Access Compliance Report

Public Rights-of-Way

Intersection ID: 18869	Main Street: MEADOWOOD_LN	Cross Street: RANDOLPH_RD	Location: S
ADA ID: 02E9026716DD	Ramp Type: PerpDiag	Initial Pass/Fail: Fail	Overall Compliance: No
Severity Score: 25			
Codes/Mitigation Info/Possible Solution		Field Measurements/Component Compliance

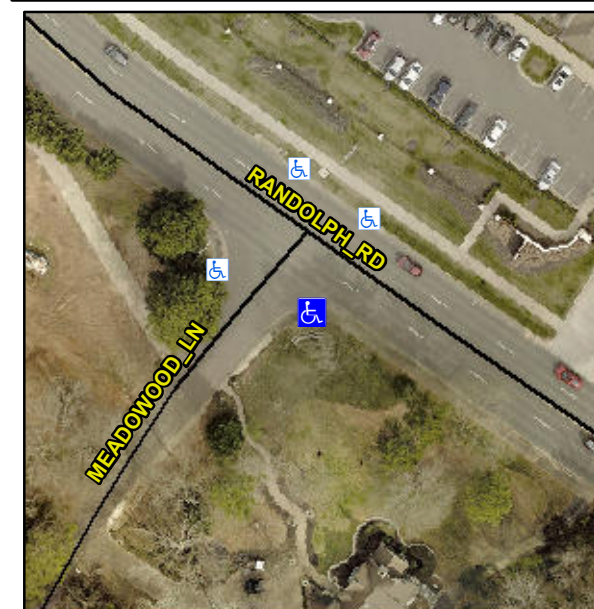
Not Found, R304.2.2, R304.5.3

Compliance	Description	Data	Compliance	Description	Data
N/A	Ramp Length (in)	63.0	No	Ramp Slope (%)	8.5
Yes	Ramp Width (in)	48.0	No	Ramp XSlope (%)	5.7
N/A	Flare Type LT	N/A	N/A	Flare Type RT	N/A
N/A	Flare Slope LT (%)	N/A	N/A	Flare Slope RT (%)	N/A
N/A	Flare Traversable LT?	N/A	N/A	Flare Traversable RT?	N/A
N/A	Landing Length (in)	N/A	N/A	DWS Provided?	N/A
N/A	Landing Width (in)	N/A	N/A	DWS Contrast?	N/A
N/A	Landing Slope (%)	N/A	N/A	DWS Length (in)	N/A
N/A	Landing X Slope (%)	N/A	N/A	DWS Full Width?	N/A
N/A	Landing Curb? (Y/N)	N/A	N/A	DWS Offset (in)	N/A
N/A	Shared Landing?	N/A			
N/A	Gutter Ponding?	N/A	N/A	Gutter Slope (%)	N/A
N/A	Gutter Lip Ht (in)	N/A	N/A	Gutter X Slope (%)	N/A
N/A	Painted X Walk1?	No	N/A	Painted X Walk2?	No
	X Walk 1 Direction	To NE		X Walk 2 Direction	To NW
N/A	X Walk 1 Width (in)	N/A	N/A	X Walk 2 Width (in)	N/A
	X Walk 1 Slope (%)	0.1		X Walk 2 Slope (%)	6.4
	X Walk 1 X Slope (%)	5.2		X Walk 2 X Slope (%)	1.9

N/A	Ramp inside XWalk1?	N/A	N/A	Ramp inside XWalk2?	N/A
	Road Slope (%)	5.1	N/A	Clear Space?	N/A
	Road X Slope (%)	6.5	N/A	Clear Space to XWalk (in)	N/A
N/A	Any Obstructions?	N/A	N/A	Storm Grate/Utility Hazard?	N/A
	Obstruction Type			Storm Grate/Utility Type	
		N/A			N/A
		Yes		Surface Condition? (G/P)	Good

Remove & Replace Curb Ramp With Two New Directional Ramps or Equivalent.
